HIDALGO COUNTY PLANNING DEPARTMENT

HIDALGO COUNTY COMMISSIONERS COURT MEETING

DATE: 04-29-2014

PROPOSED SAMANTHA SUBDIVISION, PRECINCT No. 3.

SUBDIVISION PLAT OF SAMANTHA SUBDIVISION

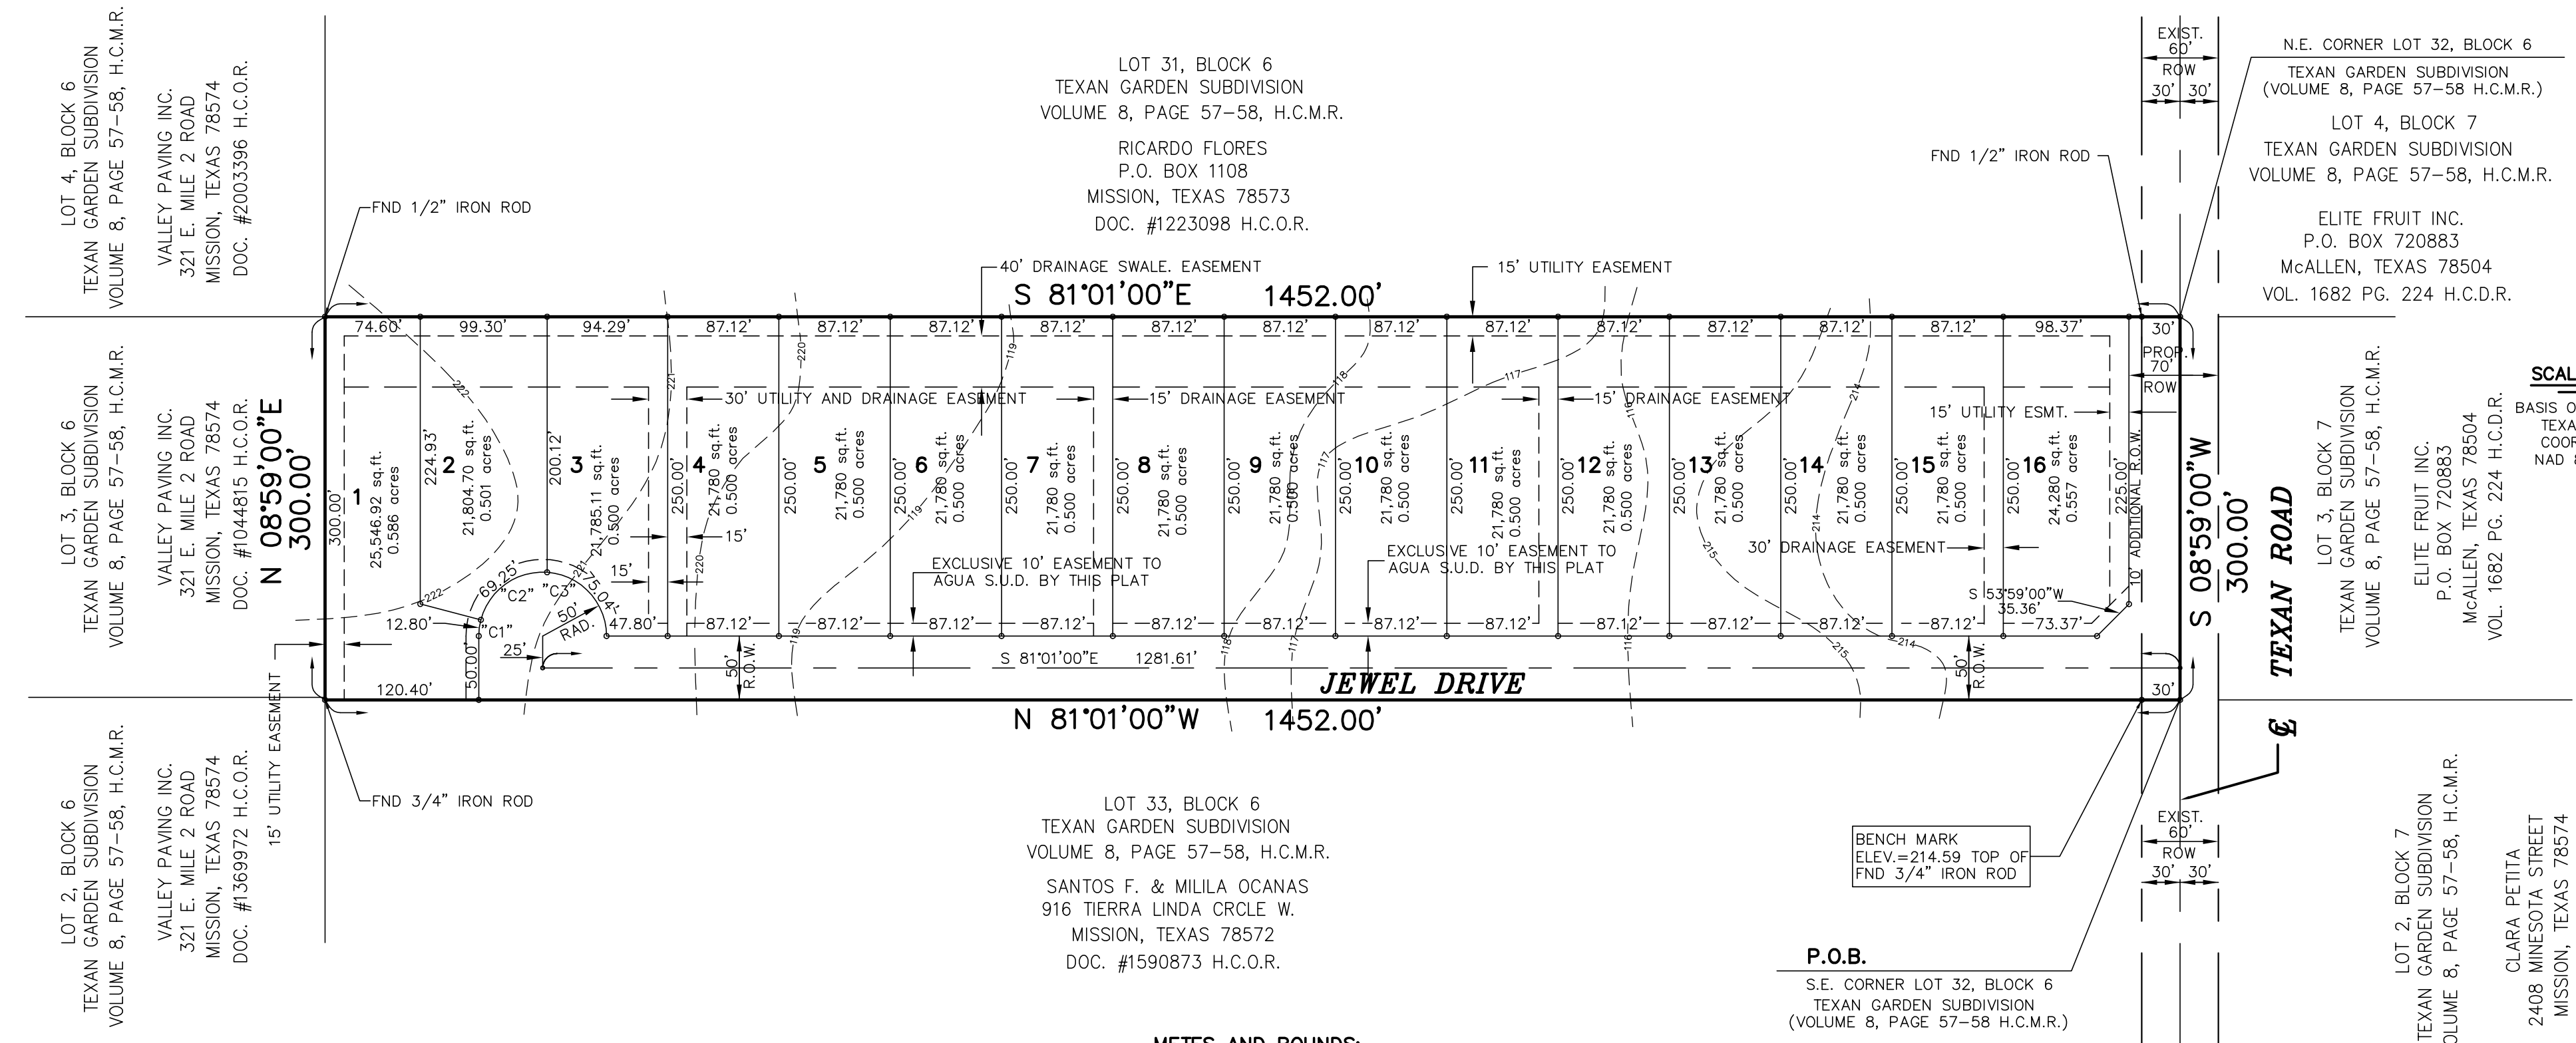
VARIANCE REQUEST ON: Chapter 2.4 General Subdivision Design Section F Item 2. Requesting a variance NOT to have to place a cul-de-sac midway at 660 feet along Jewel Drive.

STAFF RECOMMENDS: Preliminary Approval with Variance Request subject comments and future recommendations by planning and other Departments and the approval from the City of Mission
